Los Angeles Regional Water Quality Control Board

SUBJECT: REVIEW OF REVISED INTERIM REMEDIAL ACTION PLAN FOR EAST ADJACENT PROPERTIES, PURSUANT TO CALIFORNIA WATER CODE SECTION 13304 CLEANUP AND ABATEMENT ORDER NO. R4-2021-0079

SITE: SKYPARK COMMERCIAL PROPERTIES (ASSESSOR PARCEL NO. 7377-006-906), 24701 – 24777 CRENSHAW BOULEVARD AND 2530, 2540, AND 2600 SKYPARK DRIVE, TORRANCE, CALIFORNIA (SCP NO. 1499)

Attachment 1 - Figure 22 – Proposed Vadose Zone and Perched Groundwater Remediation Area

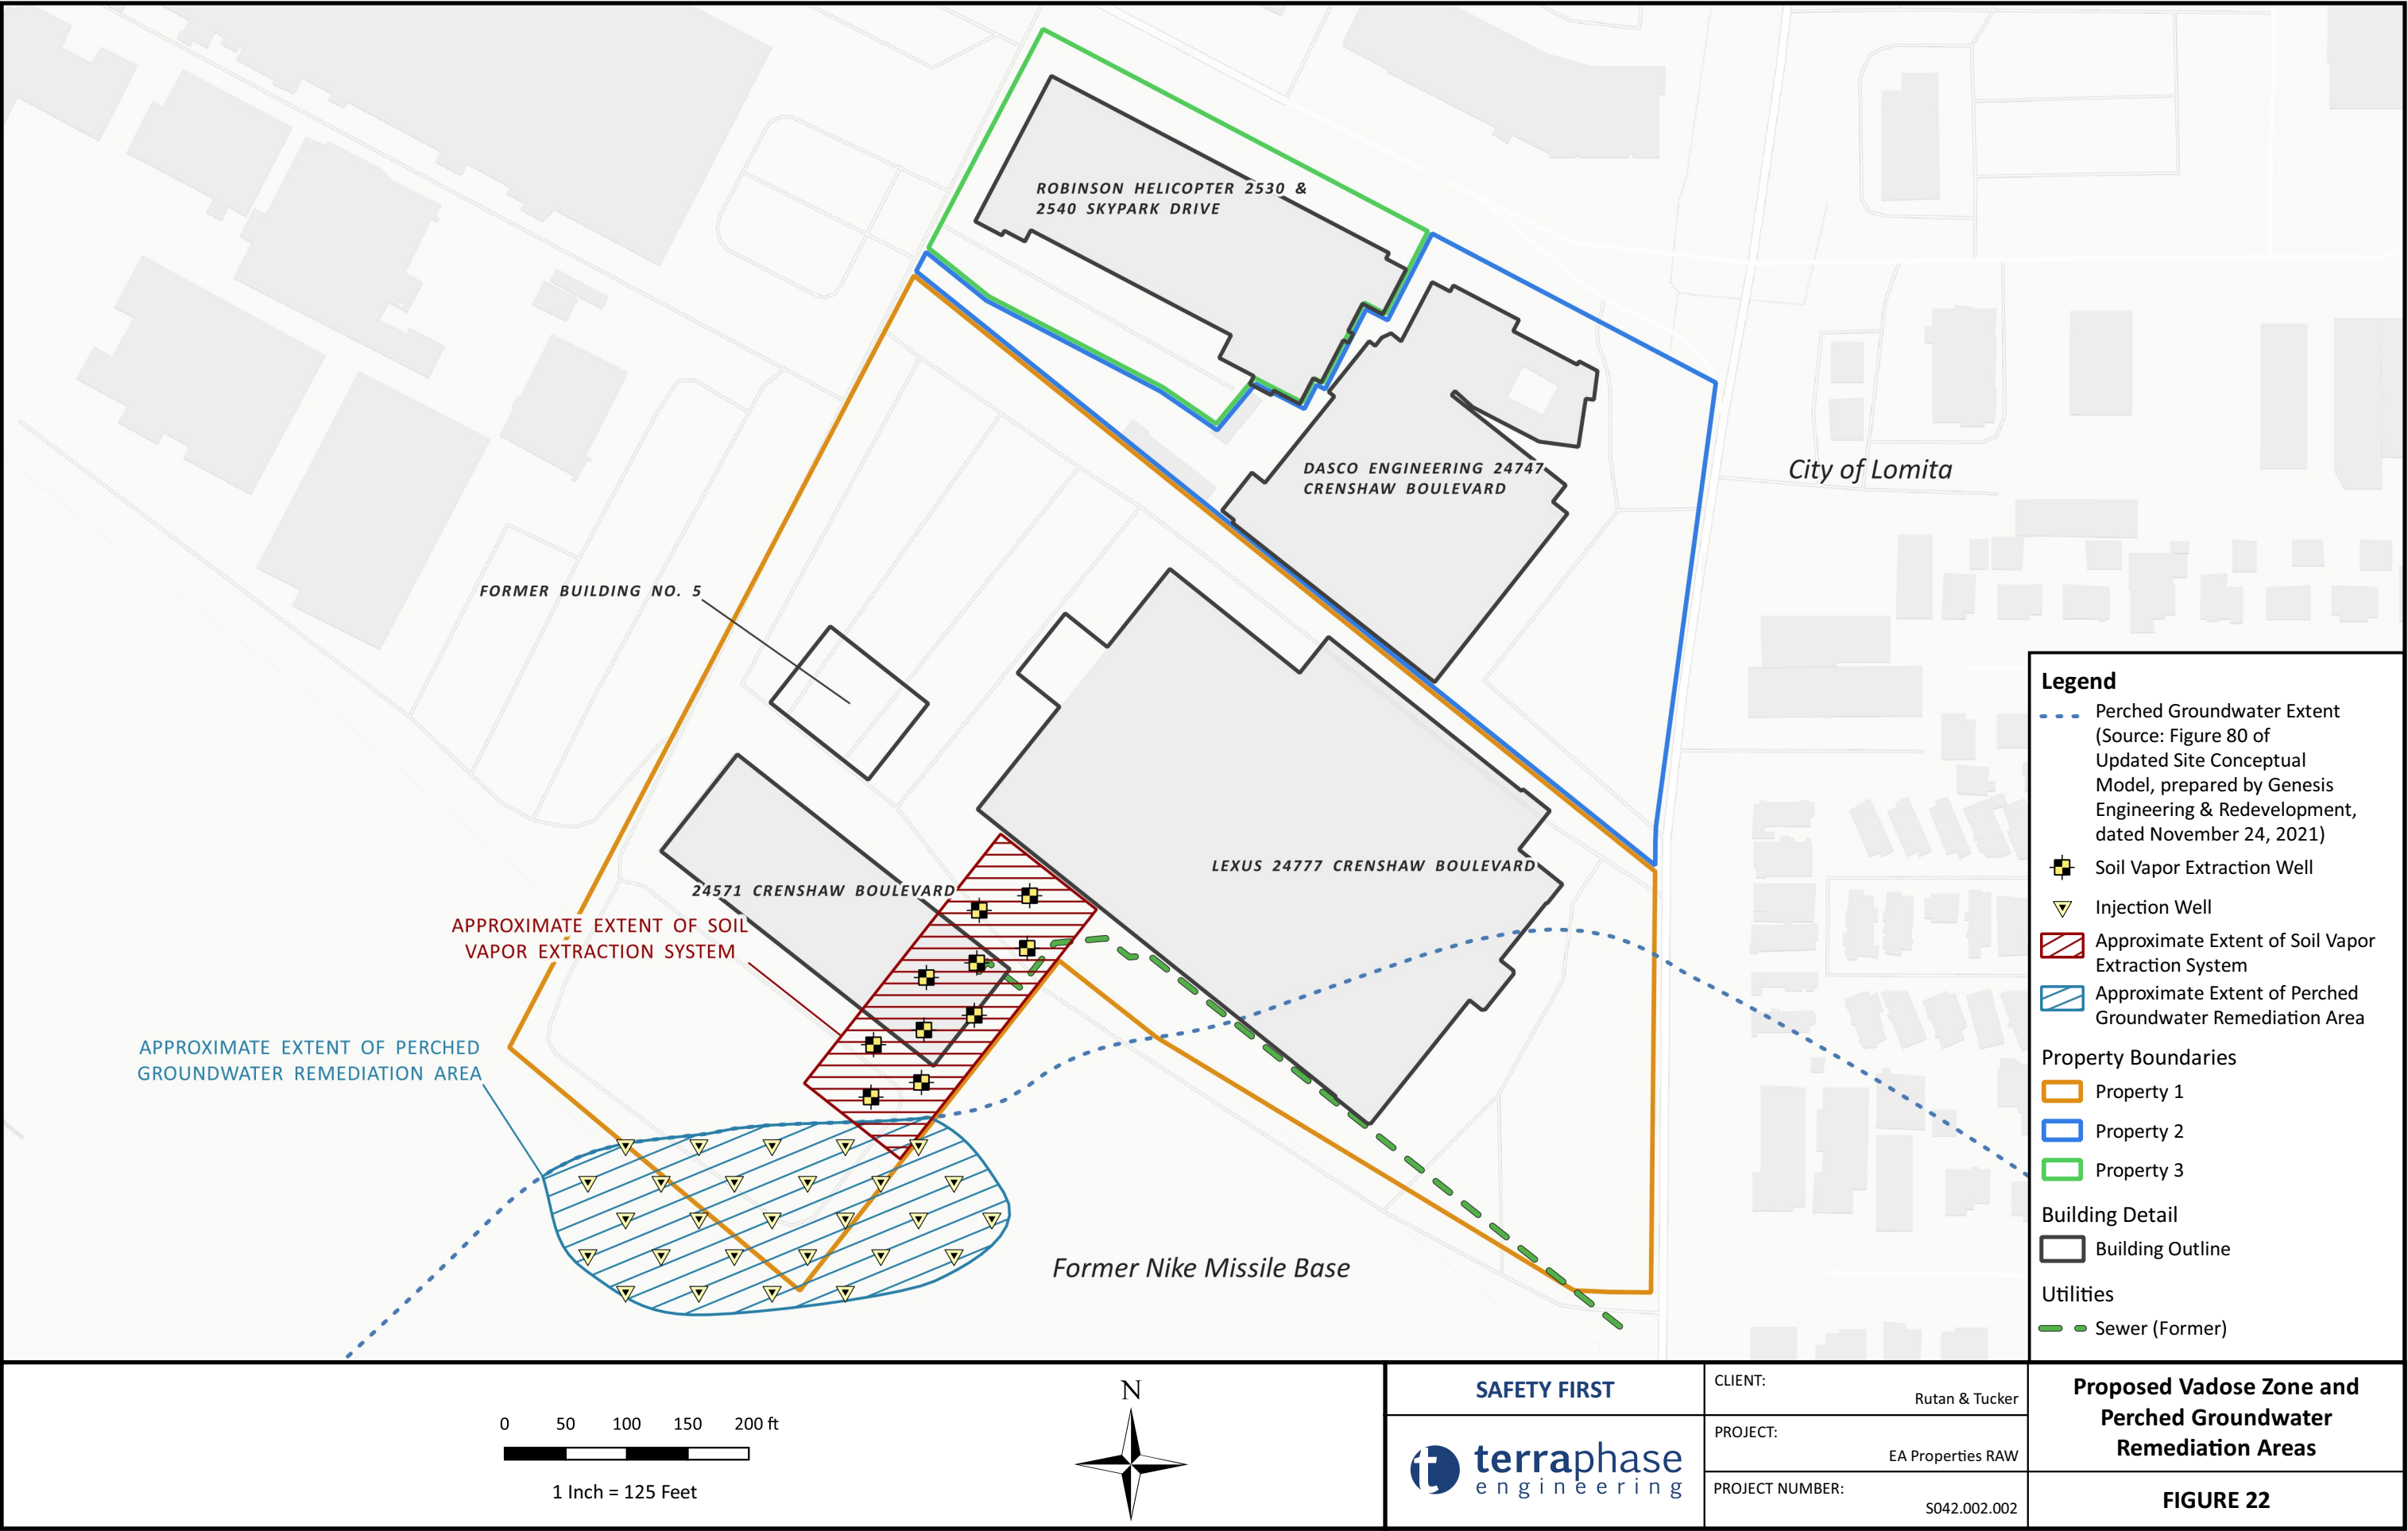
1. Vadose zone¹ will be treated using an SVE system, as shown in Attachment 1, *Figure 22 – Proposed Vadose Zone and Perched Groundwater Remediation Area* (Figure 22).
 - a. Install the system in the vicinity of the former degreasers at Property 1.
 - i. Install 30 SVE wells screened as follows:

1. Part of the Letter requiring the Revised EAP IRAP requested SVE wells to be located and screened to address the current known lateral and vertical extent of the soil vapor VOC contamination at the EA Properties. The Letter identified 14 multi-nested soil vapor probe locations that should be addressed; however, this was only partially addressed (approximately 3 of the 14 soil vapor probe locations [VP-49, VP-107, and VP-114]) by the Revised EAP IRAP. Terraphase explained that SVE wells covering nearly the entirety of the EA Properties is impractical and that the proposed SVE system was designed to address a source area (i.e., former degreasers on Property 1). Terraphase noted that the SVE system may be expanded to address additional source area(s) discovered during the implementation of the conditionally approved investigative component of the Revised EAP IRAP.

- The depiction of Vadose and Perched Groundwater Remediation Areas, as shown in Figure 22, is premature until the investigation component of the EAP IRAP and other activities are completed. The rationale for selecting the southern area of EA Property 1 for treatment is not clear. The characterization of this area is incomplete, and the depiction of the treatment area is not consistent with a known or identified source area, unless that source area exists on the former Nike Missile site (which is the only possible explanation based on the depicted location). There is no rationale for a remedial system at the eastern end of the EA Property 1 small building as no source in that location has yet been identified. The decision on remedial approach should come after this additional characterization is performed. This figure should be deleted.

Los Angeles Water Board partially concurs with Terraphase's explanation and rationale at this time; however, the expansion of the SVE system shall not be limited to just the findings from the conditionally approved investigative component of the Revised EAP IRAP. The expansion of the SVE system may be warranted

based on updated environmental data, any discovery of additional source area(s) from the conditionally approved investigative component of the Revised EAP IRAP, and/or any future investigations and assessments. The installation of the SVE system shall proceed, as proposed, such that its future expansion(s), if necessary, can be accommodated for and conducted in a phased manner.

Attachment 2 - Figure 21 – Proposed Regional Groundwater Remediation Area

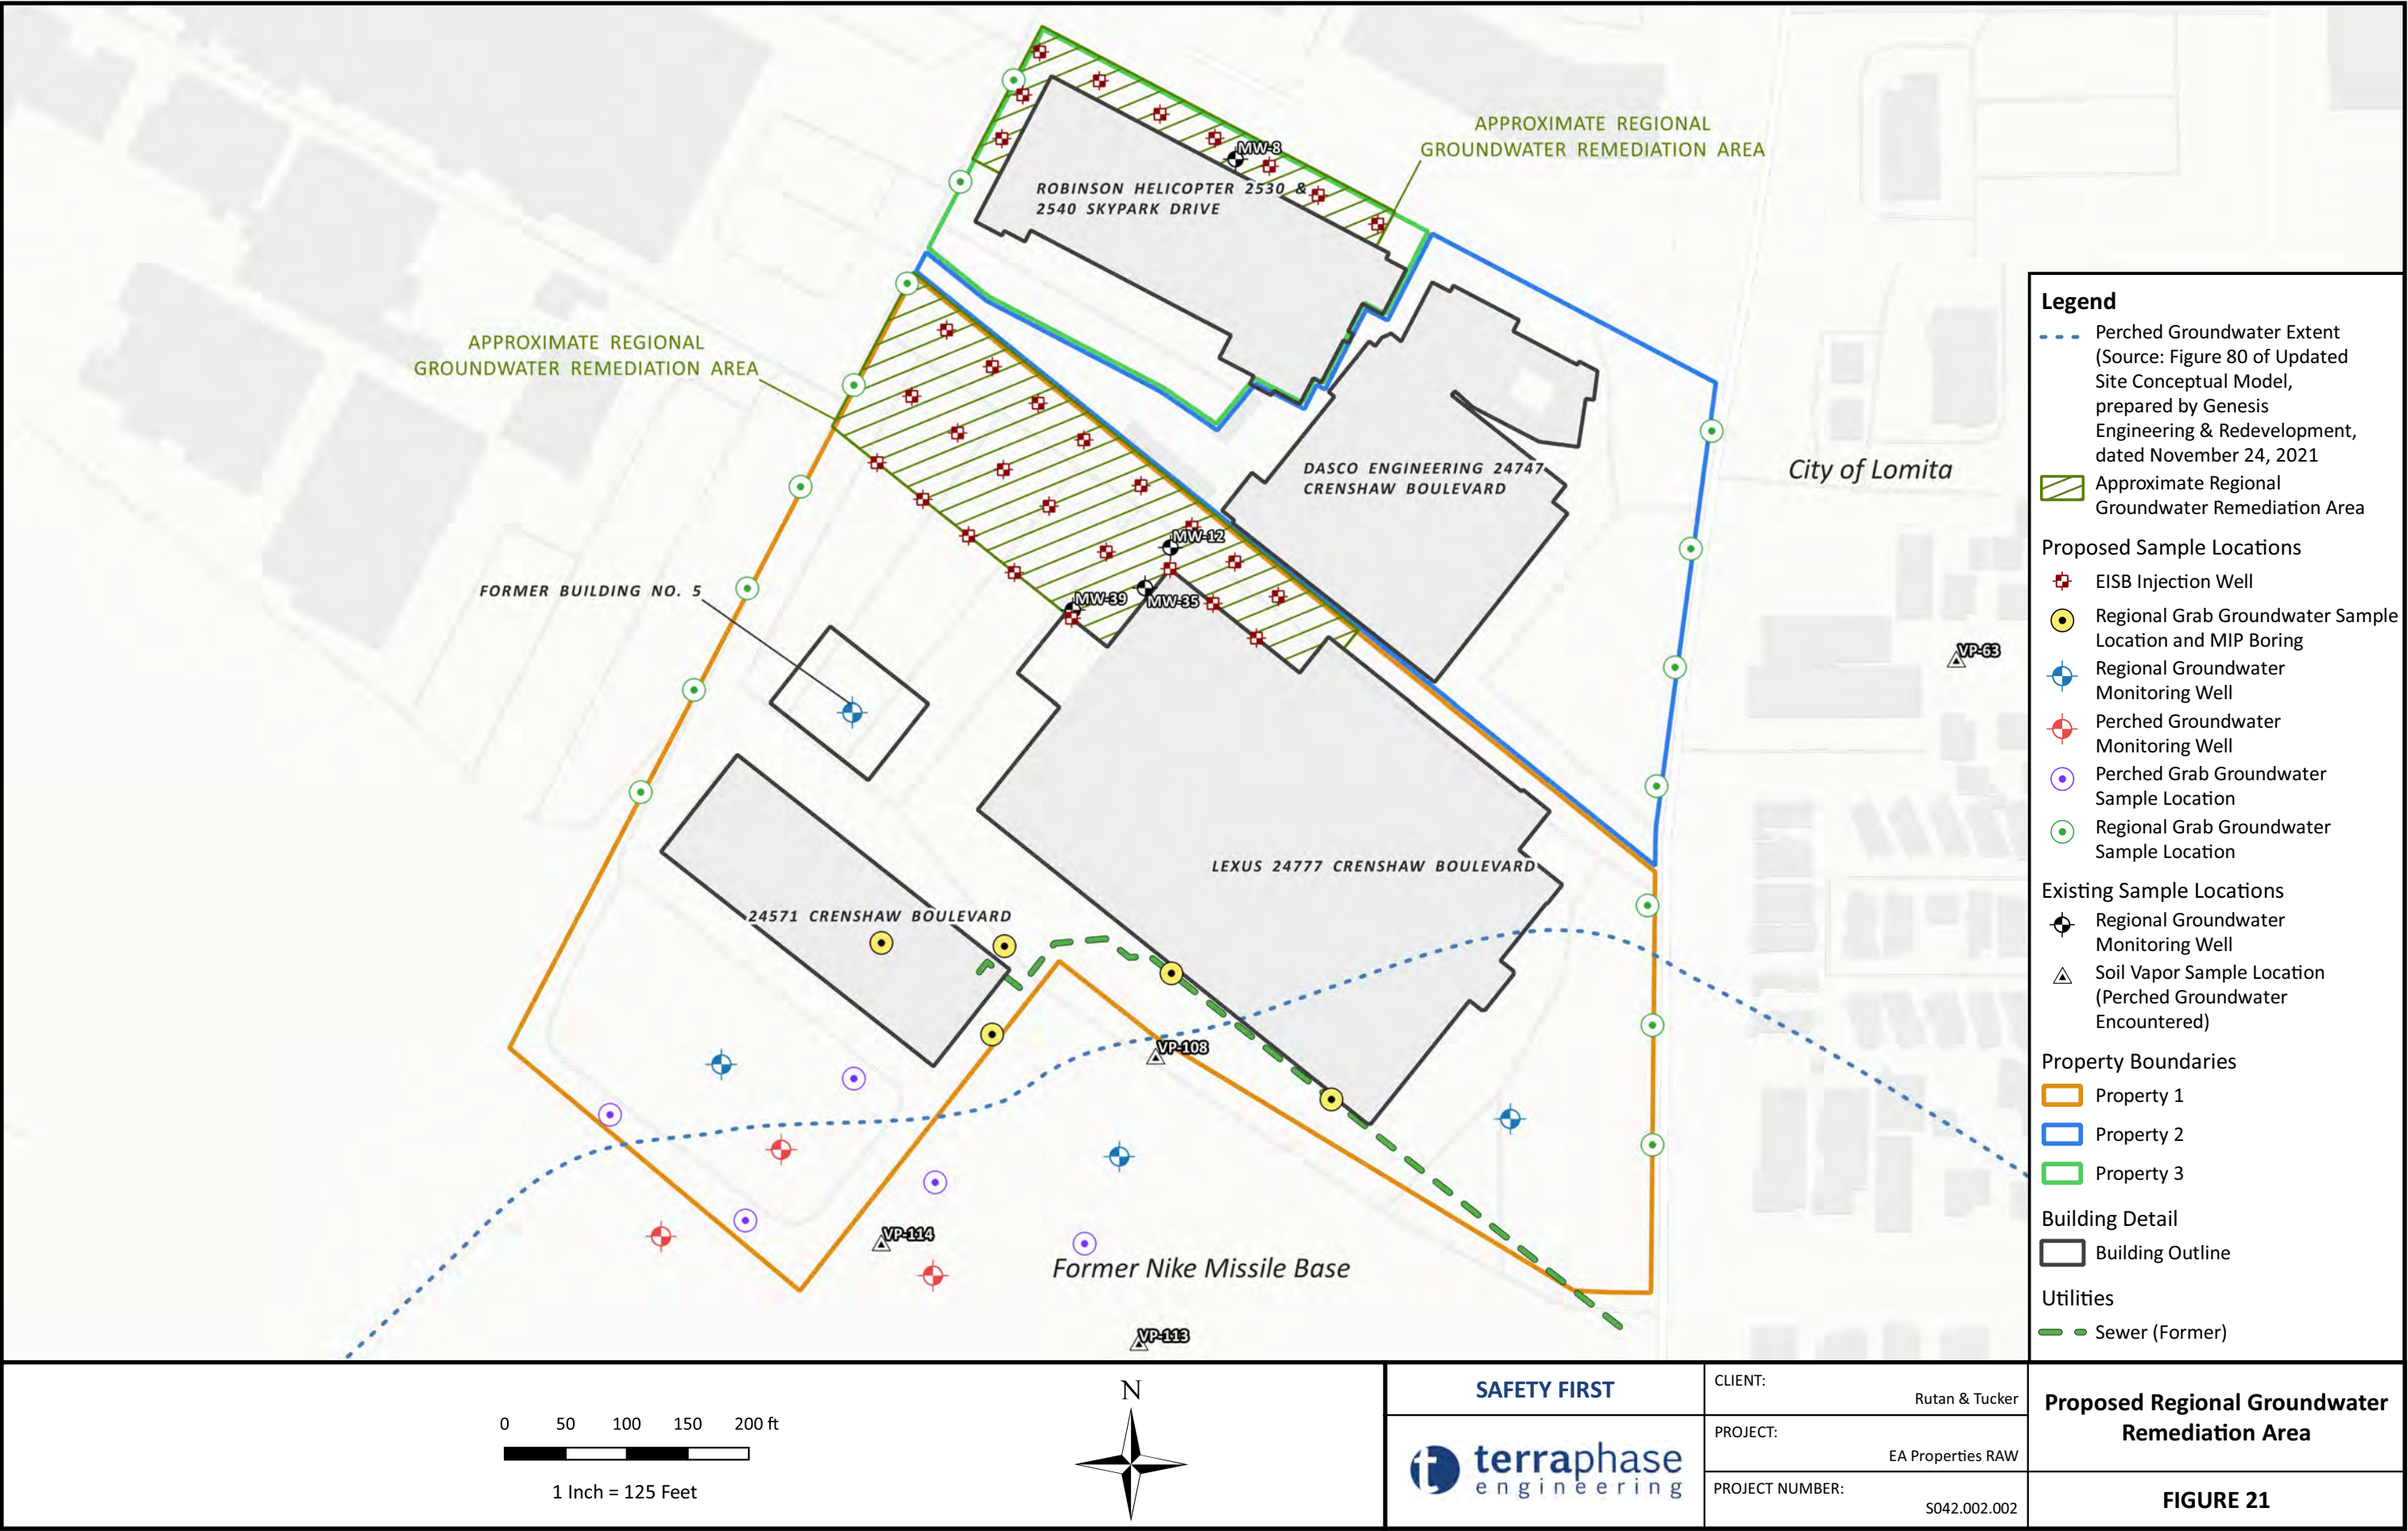
3. Regional groundwater³ will be treated using EISB, as shown in Attachment 2, *Figure 21 – Proposed Regional Groundwater Remediation Area* (Figure 21).

- Figure 21 labeled “Proposed Regional Groundwater Remediation Area” should be deleted. If it is retained, it should be labeled as depicting “Conceptual Groundwater Remediation Area.” While bioremediation has been shown to be successful in correctly designed situations, the EAP IRAP appears to have selected and preliminarily “designed” a bioremediation as a remedy, without the performing the design characterization activities necessary to implement a technically effective and cost-efficient remedy. The rationale for selecting the groundwater remedy area in Figure 21 has not been made clear, as the investigative component of the work has not been completed. For that reason, this figure should be deleted or relabeled as set forth above.
